#### SOUTH AUSTRALIA – VICTORIA (HEYWOOD) INTERCONNECTOR UPGRADE

The National Generators Forum appreciates the opportunity to comment on the ElectraNet and AEMO *Regulatory Investment Test - Transmission, Project Assessment Draft Report (PADR) for the proposed upgrade of the South Australian – Victoria (Heywood) Interconnector*, published in September 2012.

*Table 1: Changes in wind farm investment, Central Scenario, Option 1b*

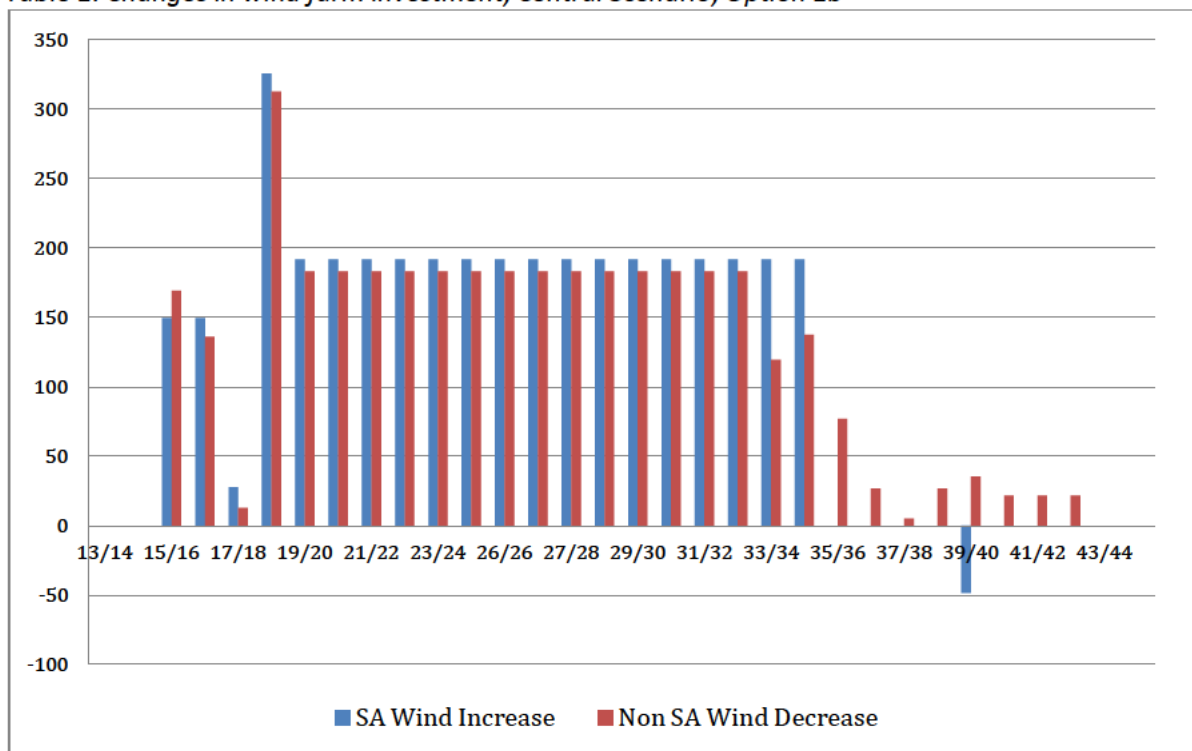
Analysis of data contained in Appendix E indicates substitution of generation between regions based on an increase in CCGT construction in Victoria exceeding 450 MW with a corresponding decrease in CCGT construction in SA also exceeding 450 MW. With regard to wind farms in South Australia an increase of 192 MW with a subsequent decrease in non South Australian wind generation of 183 MW, a one for one substitution.

The nominal increases on the Heywood interconnector are significantly less than the generation substitution between regions as detailed by the proponents in Appendix E of the PADR.

The NGF seeks clarification from the proponents as to how the proposed upgrade supports the level of generation substitution between the regions contained in the modelling results.

Analysis of data contained in Appendix E of the PADR, indicates relatively minor changes in the construction of wind farms in non-South Australian regions when combined with the modelled investment in new wind farms in South Australia. The PADR shows a near one for one substitution of wind farm versus the other regions. There is no material market benefit from capital deferral.
